PLANT NAME: H. B. ROBINSON UNIT #2

H. B. ROBINSON UNIT NO. 2
LICENSE DPR-23

CONTINUED IRRADIATION OF GADOLINIUM TEST ASSEMBLIES

DESCRIPTION AND EVALUATION OF TEST ASSEMBLIES CONTAINING GADOLINIA BEARING FUEL RODS -- H. B. ROBINSON UNIT NO. 2 CYCLE 3

Figure 1
Core Loading Arrangement

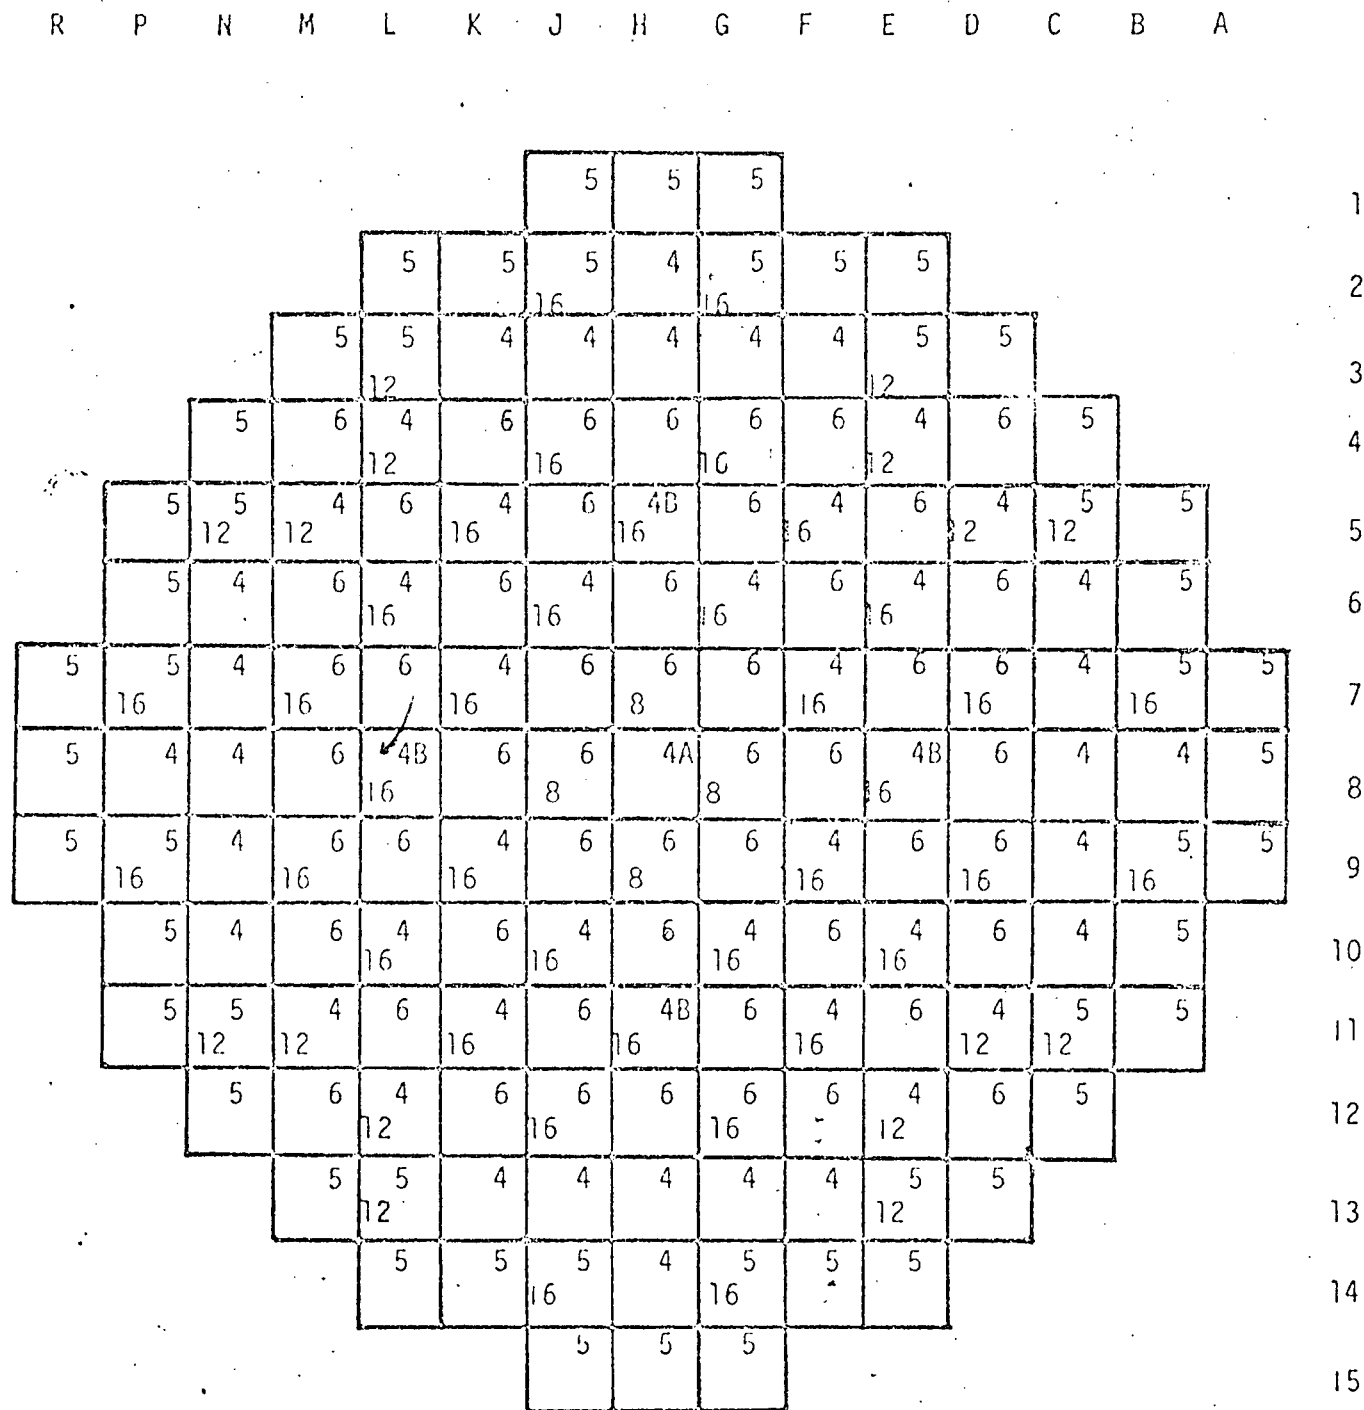
The assemblies containing 3.0 w/o gadolinium will be installed in the E-8 and L-8 core positions (see Figure 1) during cycle 3. Assemblies containing 1.85 w/o gadolinium will be installed in core positions H-5 and H-11 during cycle 3. Each of the gadolinia assemblies will contain sixteen borosilicate burnable poison rods during cycle 3.

Figure 2
Predicted Assembly Power Distribution
H. B. Robinson Unit 2 Cycle 3

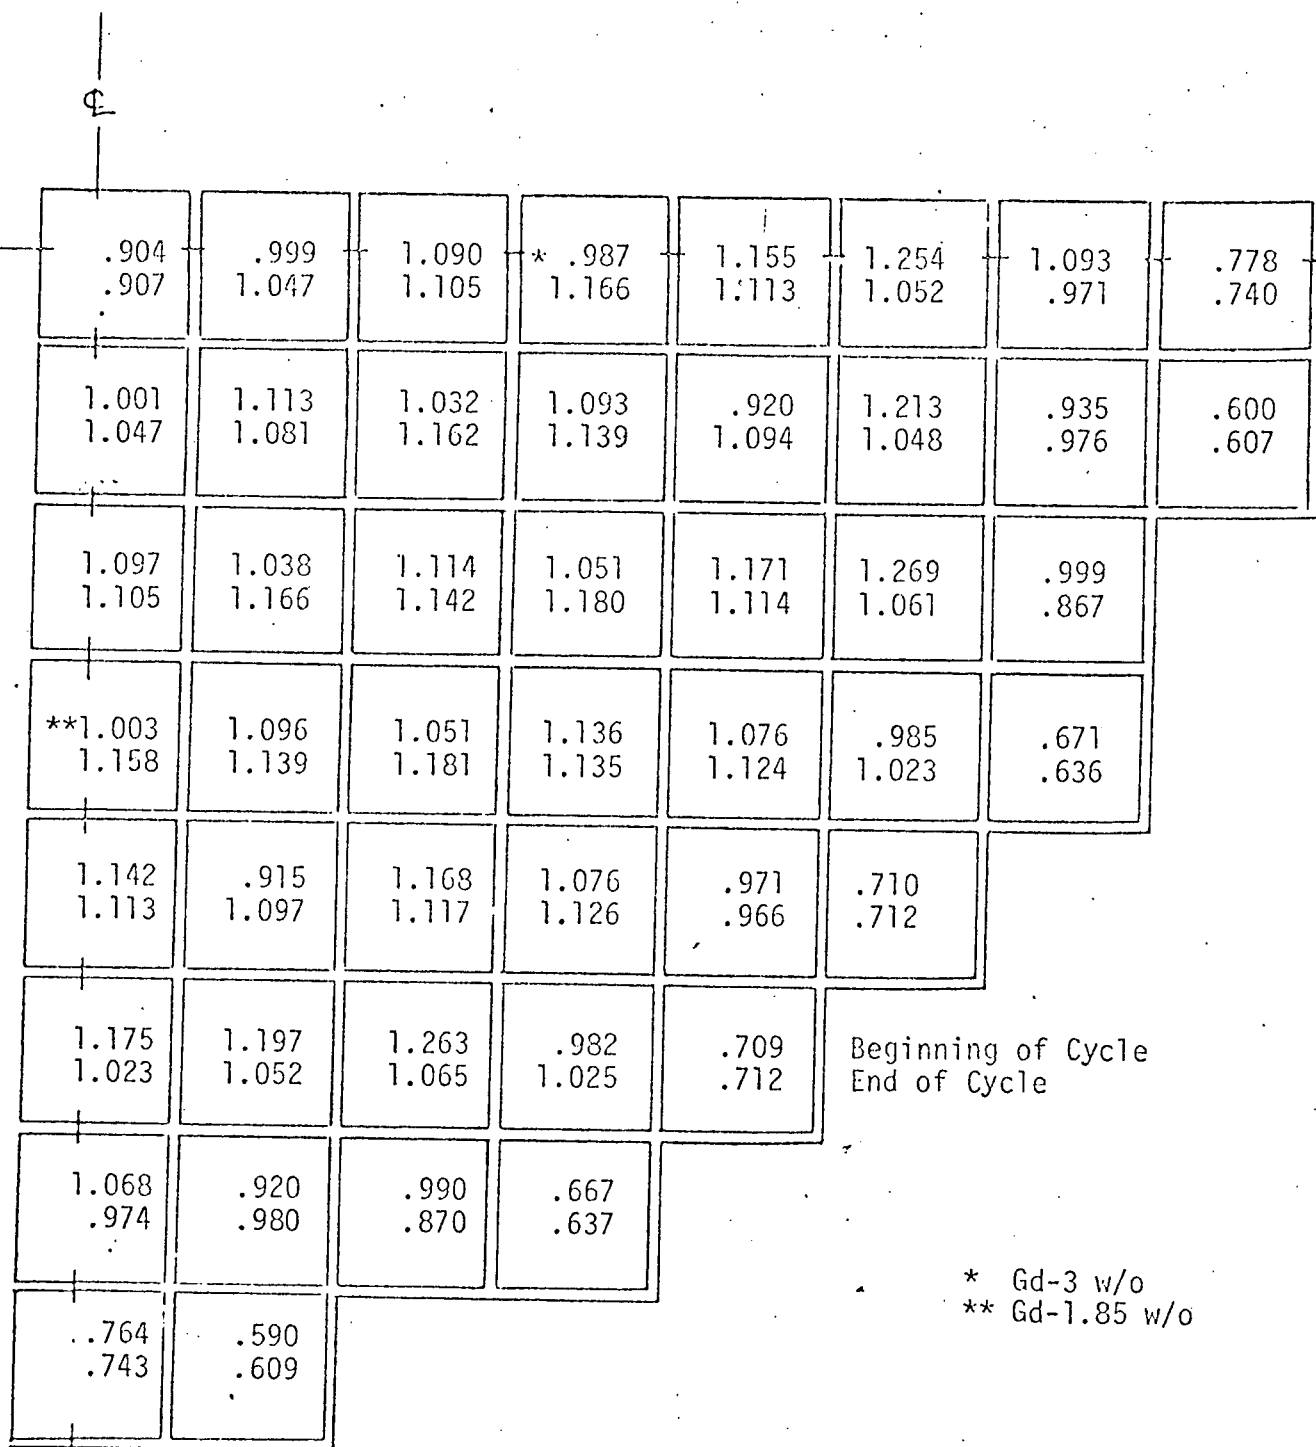
The predicted cycle 3 core power distributions at the beginning and end of the cycle are given in Figure 2. As previously noted, the gadolinia assemblies will contain borosilicate burnable poison rods during cycle 3. The core distribution of borosilicate burnable poison rods is given in Figure 1. Figure 3 gives the predicted peak gadolinia rod power relative to the core average rod power. The peak power (predicted) rod of each gadolinia enrichment is given as a function of cycle 3 burnup. Also shown in Figure 3 is the gadolinia fuel design limit of 1.15 (1.435×0.8). Although the predicted gadolinia assembly power is high at the end of reactor cycle 3 (Figure 2), the highest power gadolinia rods are predicted to be nearly equal to the core average rod. The minimum margin between the peak gadolinia rod power and the design limit is approximately 13%.
